A417 Missing Link

Cotswolds Conservation Board - Options Report

HE551505-ARP-HGN-X_XX_XXXX_X-RP-C-000005

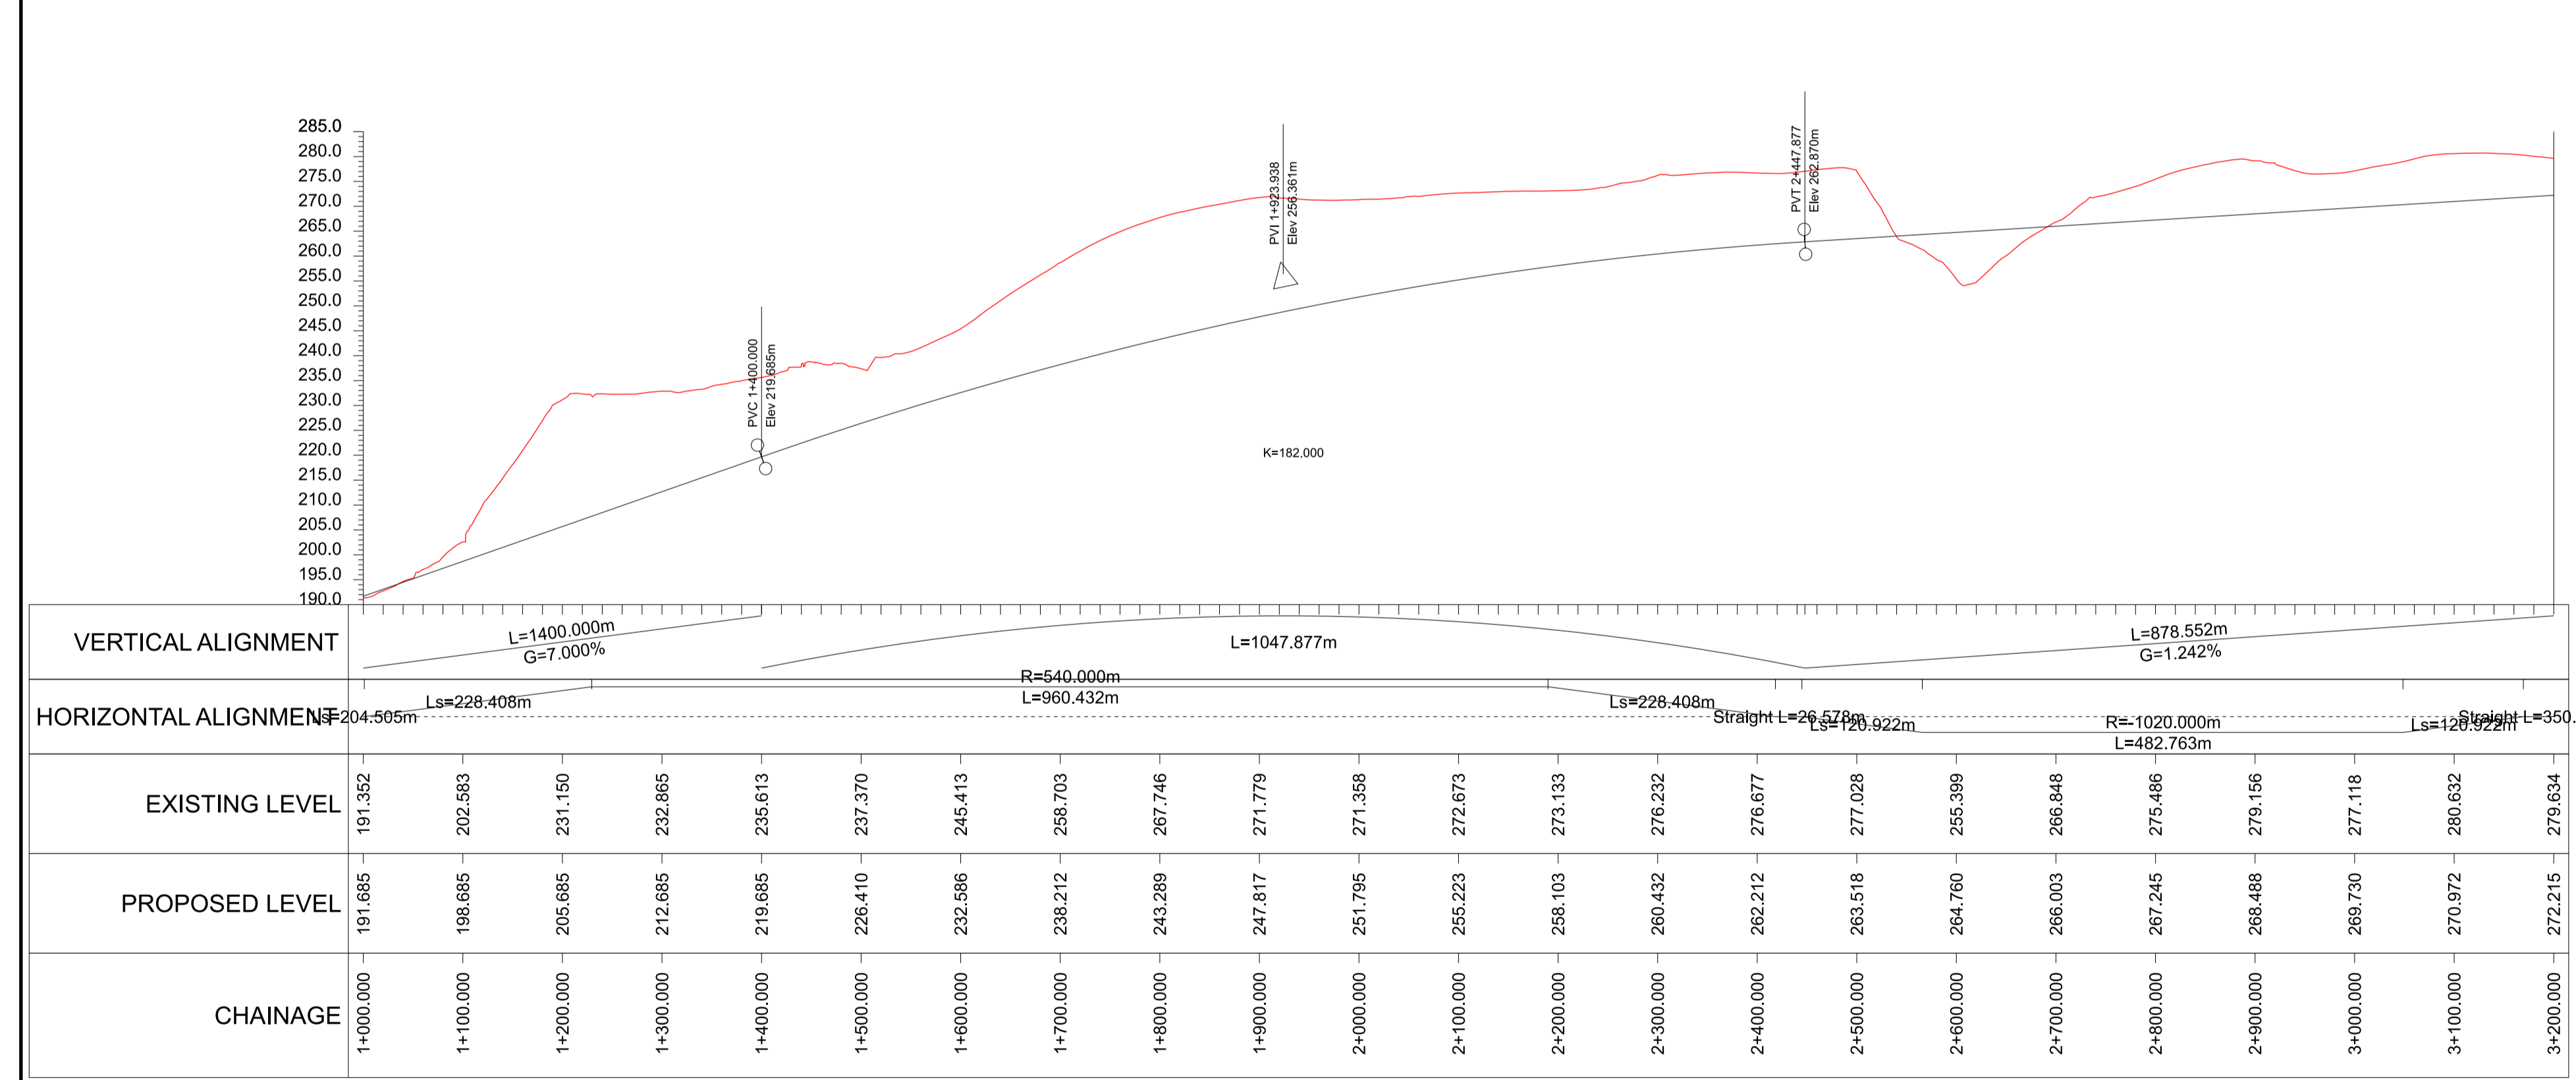
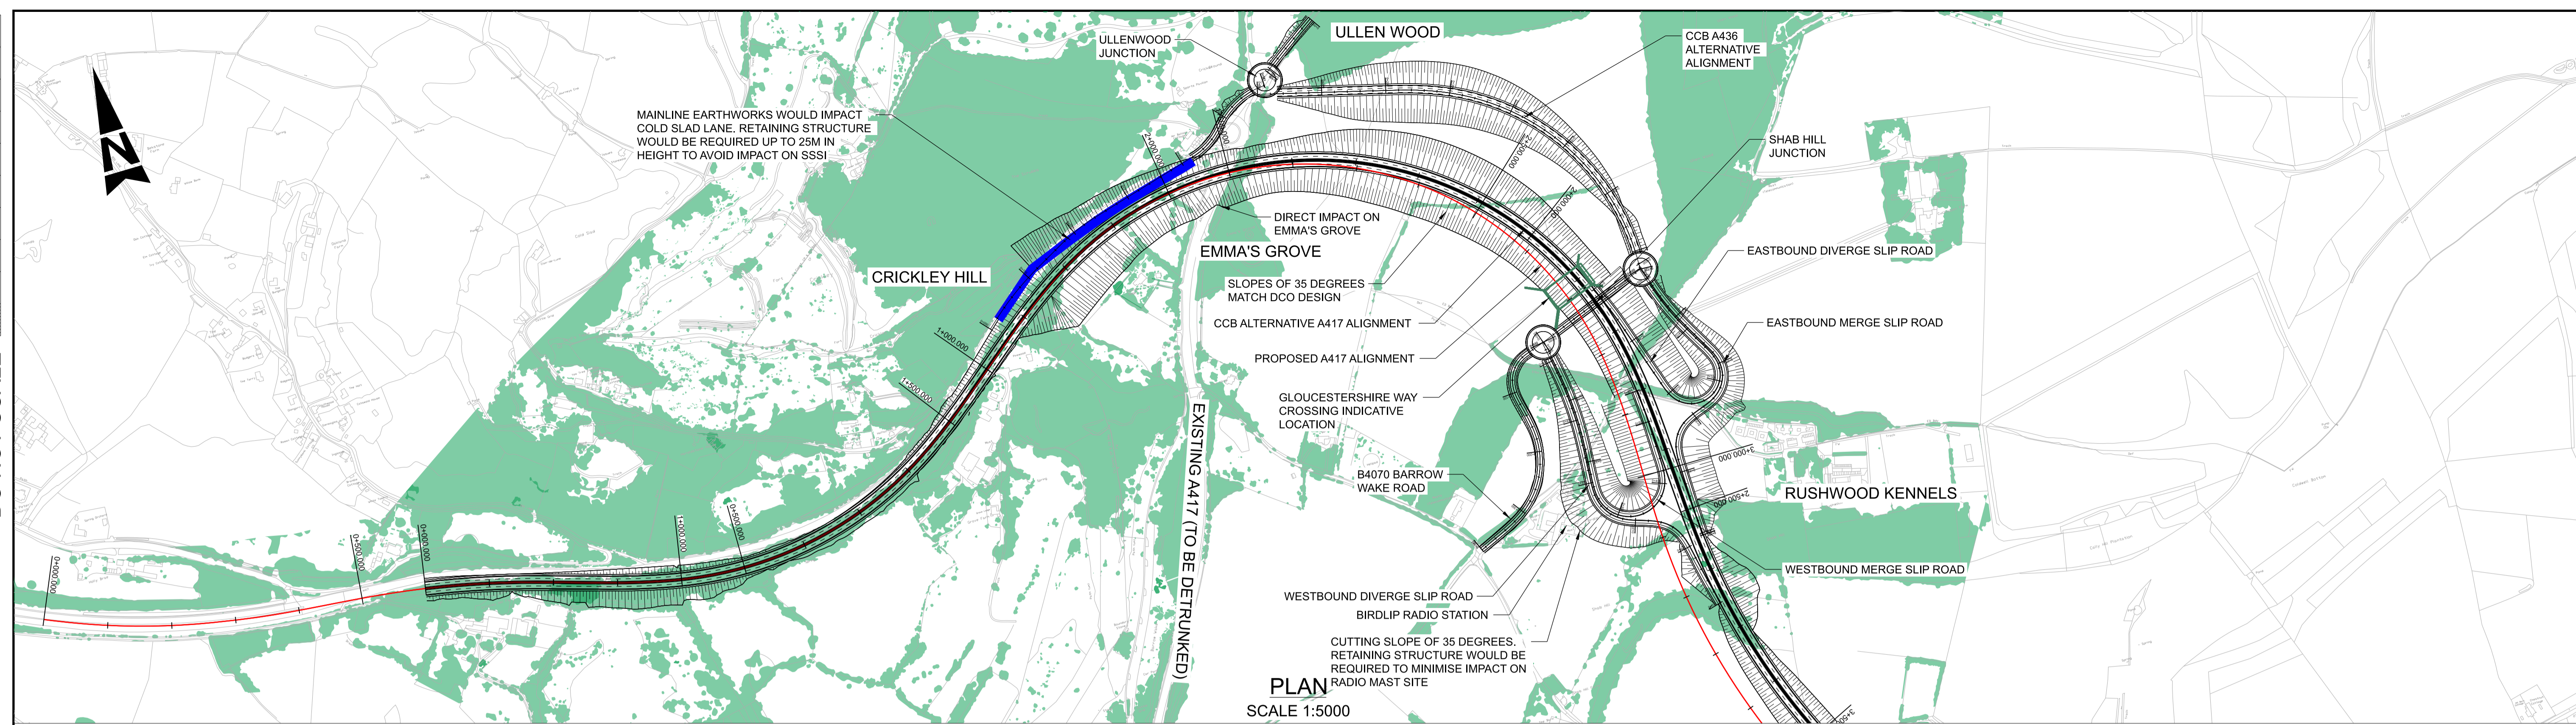
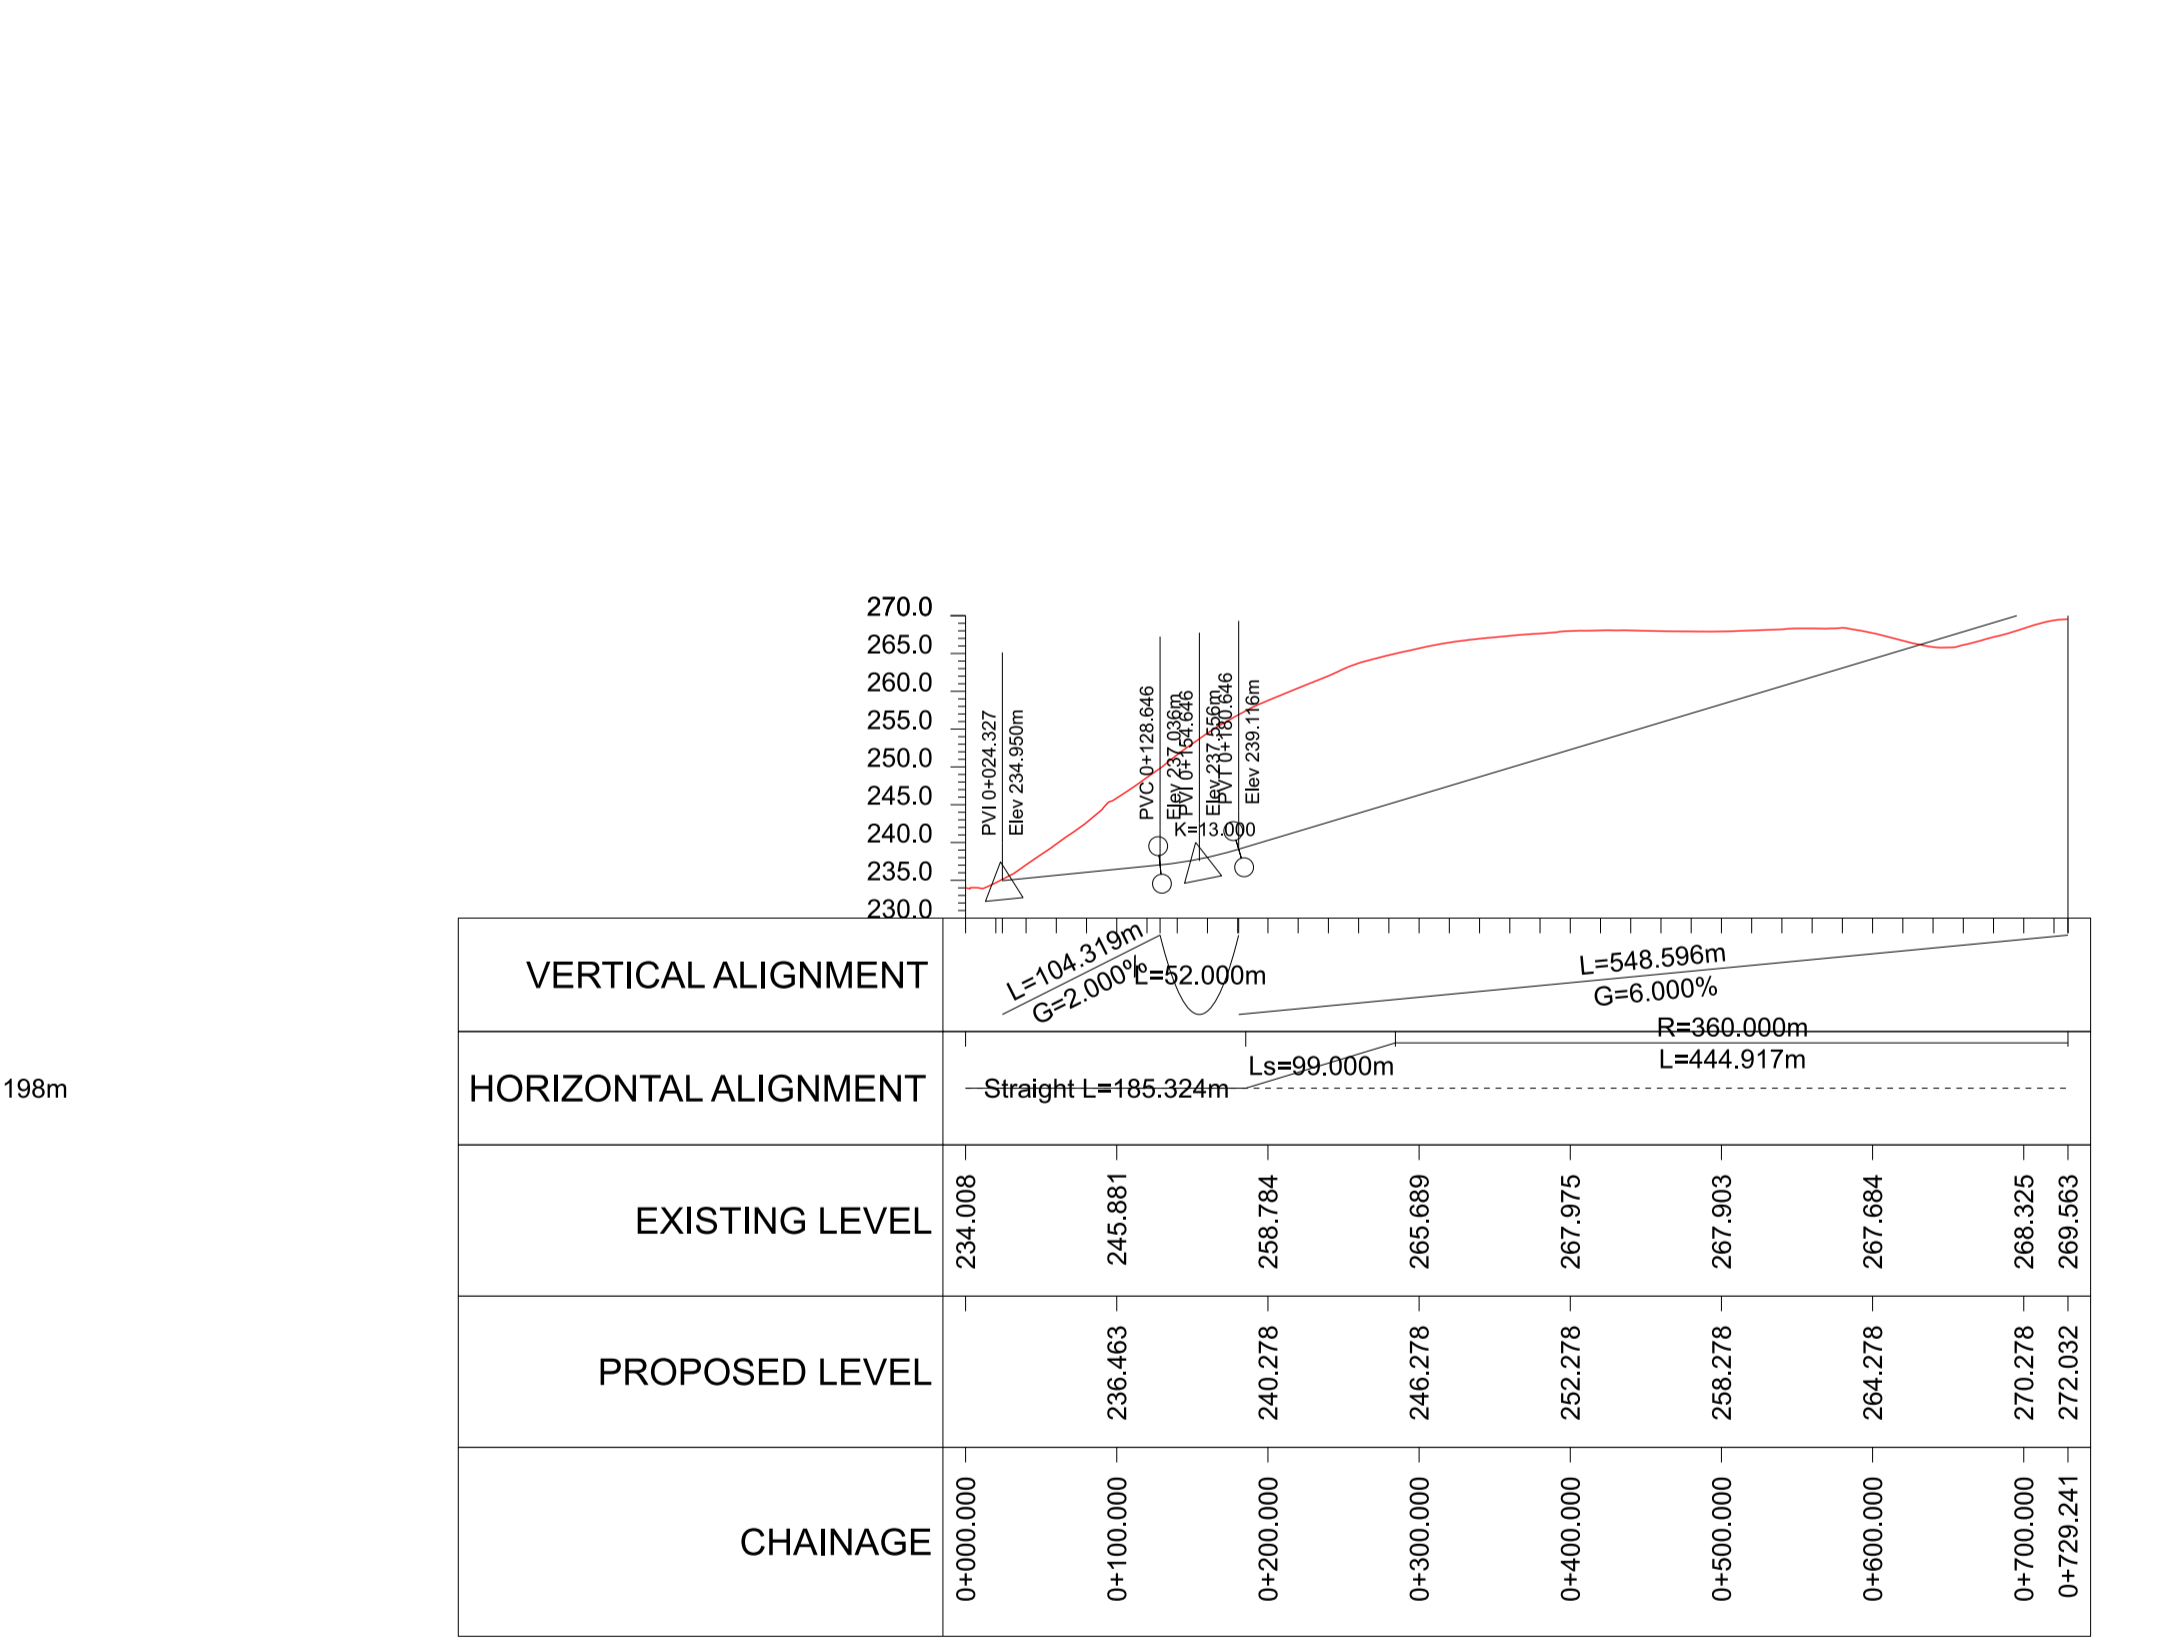
- 6.4.3 The plan/profile drawings HE551505-X_XX_XXXX_X-SK-C-000097 and 000098 in Appendix C, demonstrate the layout when designed in compliance with current highways design standards.
